UNITED STATES
DEPARTMENT OF THE INTERIOR
BUREAU OF LAND MANAGEMENTFORM APPROVED
OMB NO. 1004-0137
Expires: January 31, 2018**SUNDRY NOTICES AND REPORTS ON WELLS**
*Do not use this form for proposals to drill or to re-enter an abandoned well. Use form 3160-3 (APD) for such proposals.*5. Lease Serial No.
NMNM118108

☐ Oil Well ☒ Gas Well ☐ Other2. Name of Operator
CHEVRON U.S.A. INC.Contact: DORIAN K FUENTES
E-Mail: djvo@chevron.com9. API Well No.
30-015-439273a. Address
ATTN DORIAN FUENTES 6301 DEAUVILLE BLVD
MIDLAND, TX 797063b. Phone No. (include area code)
Ph: 432-687-763110. Field and Pool or Exploratory Area
PURPLE SAGE; WOLFCAMP (GAS)

CVX respectfully request the ability to change the BOPE rating for the selected well from a 10M system to a 5M system. The max mud weight at 10500' for the pore pressure is a 13.0 ppg. The MASP under these assumptions will be 4788 psi. The attached documents reflect a 5M system BOPE rating and test pressures.

BLOWOUT PREVENTOR SCHEMATIC

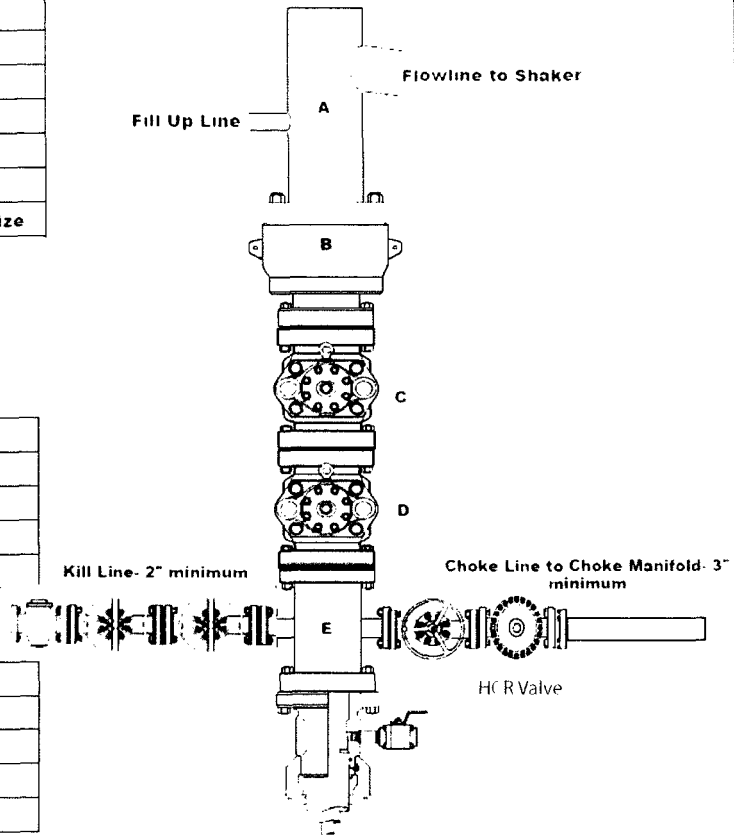
CVX requests a variance to use a FMC Technologies UH-2 multibowl wellhead, which will be run through the rig floor on surface casing. BOPE will be nipples up and tested after cementing surface casing. Subsequent tests will be performed as needed, not to exceed 30 days. The field report from FMC Technologies and BOP test information will be provided in a subsequent report at the end of the well. Please refer to the attached wellhead schematic.

Operator has proposed a multi-bowl wellhead assembly. This assembly will only be tested when installed on the surface casing. Minimum working pressure of the blowout preventer (BOP) and related equipment (BOPE) required for drilling below the surface casing shoe shall be 5000 (5M) psi.

5M system requires an HCR valve, remote kill line and annular to match. The remote kill line is to be installed prior to testing the system and tested to stack pressure.
